MEMORANDUM

SUBJECT: Site Plan Approval – 202 Factory Street and 176 Polk Street

DATE: April 27, 2023

Request: Site Plan Approval to construct a 40-space parking lot at **202 Factory Street and 176 Polk Street**, Parcel Numbers 6-02-206.000 and 6-02-205.000

8 RAIN GARDEN DETAIL
C503 NOT TO SCALE

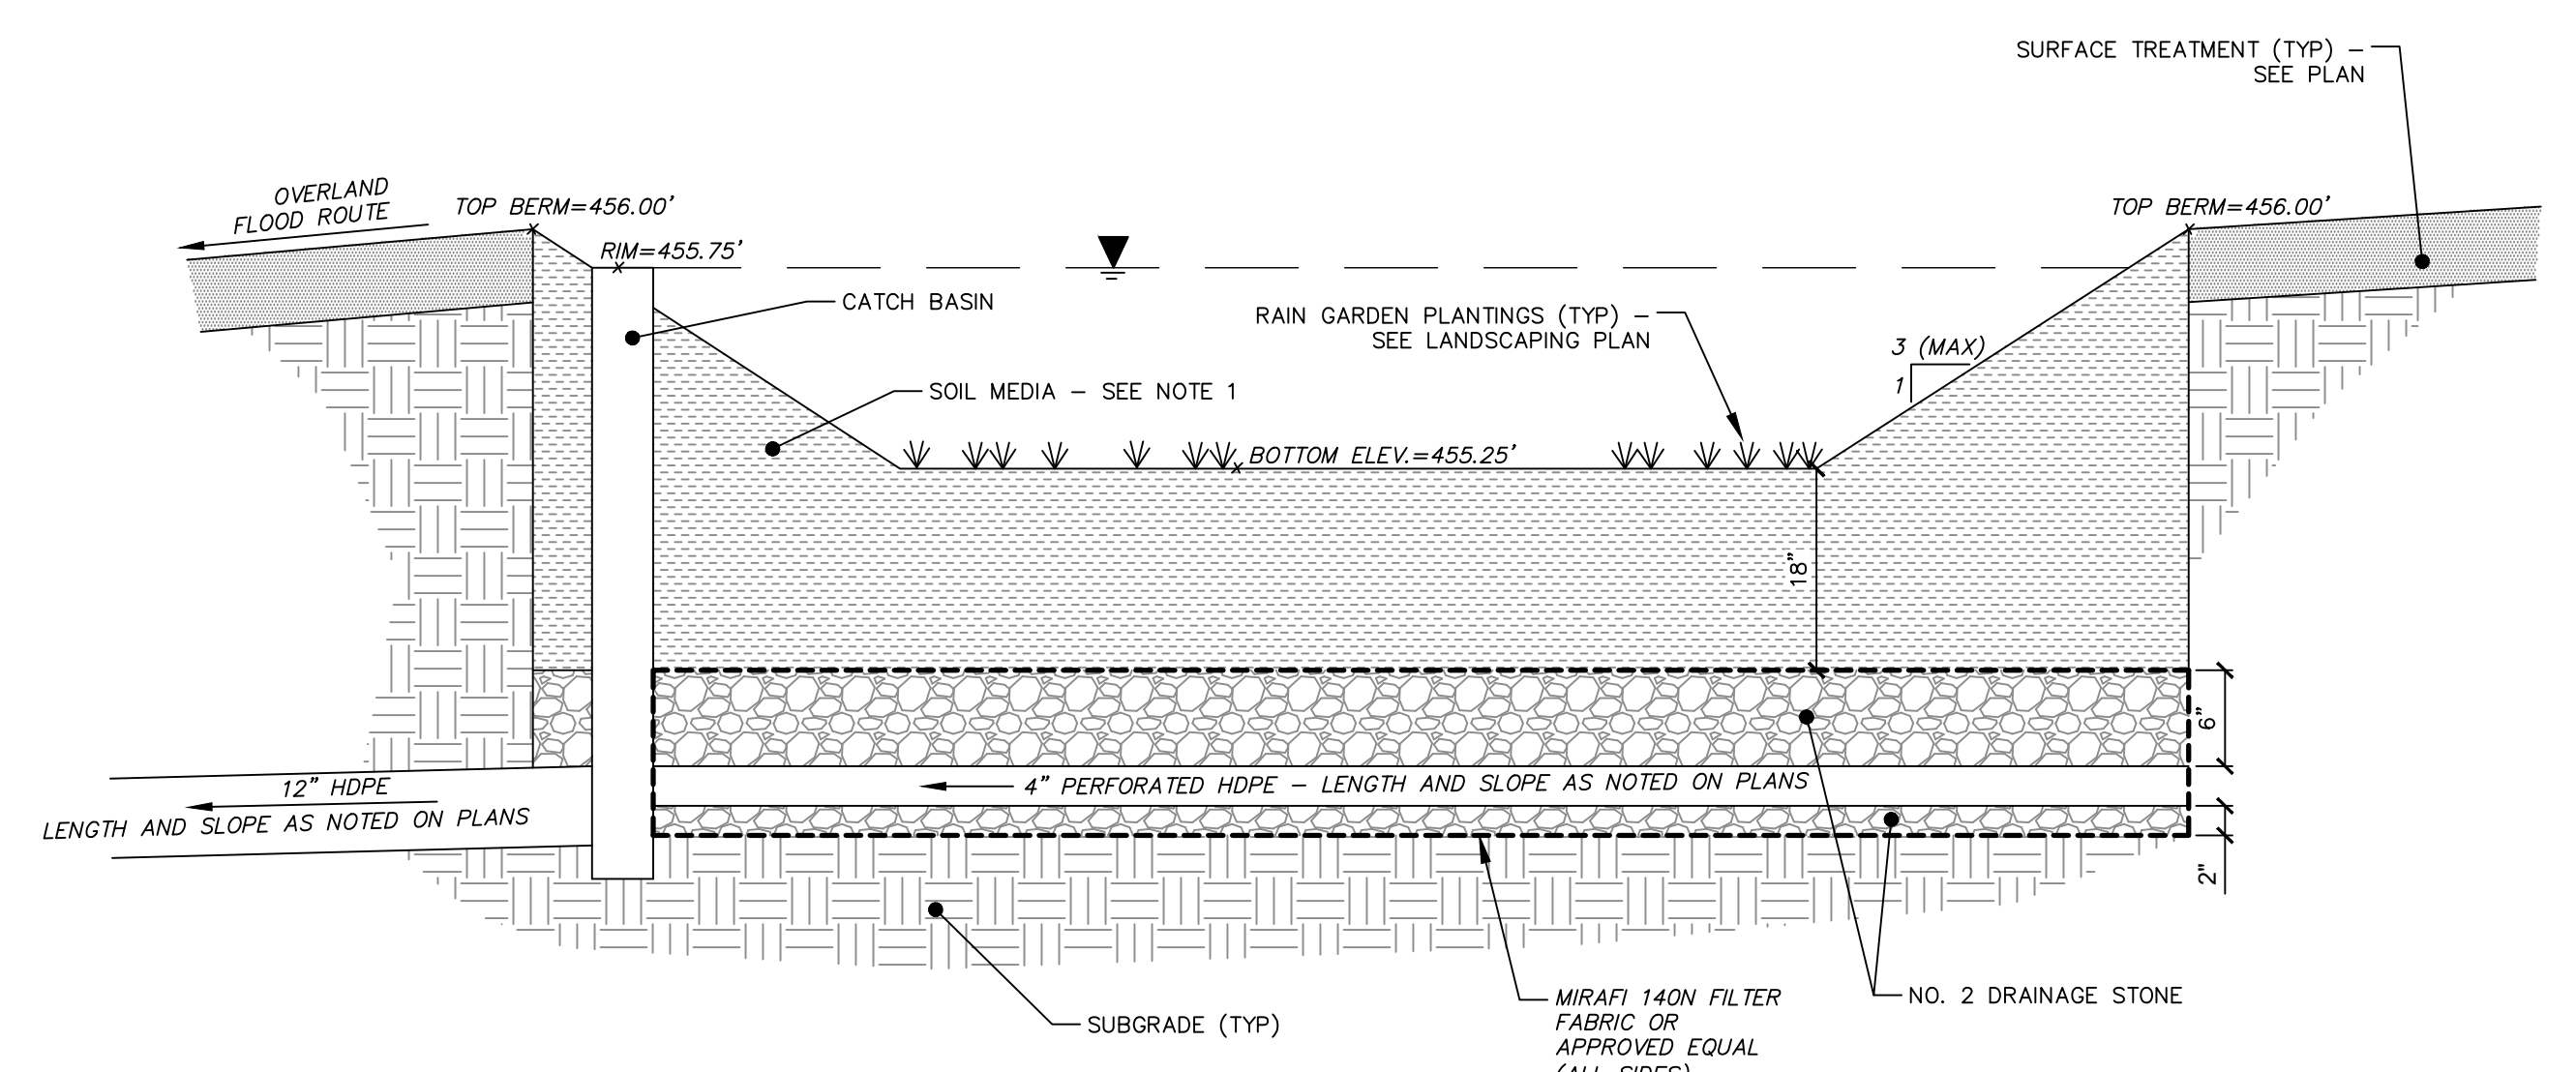
As the City will require the owner will to permanently maintain the landscaping in a healthy growing condition and assume responsibility for replacing any plant material that dies after planting, the applicant shall add a topsoil detail and note to the plan that indicates a minimum topsoil depth to be provided throughout the full width and length of the landscape setback areas. Staff recommends a minimum topsoil depth of 16 inches. The plan, as submitted, includes a detail for the rain garden area that depicts the soil media to be installed at a depth of 18”.

1. The applicant shall add a topsoil detail and note to the plans that require a minimum topsoil depth of 16” to be provided throughout the full width and length of the landscape setback areas.
2. The Planning Commission must complete Part 2 of the SEQR Short EAF and make a determination of significance.
3. The applicant must obtain, minimally, the following permits prior to construction: General City Permit for work within the Right-of-Way (ROW) and a Zoning Compliance Certificate.
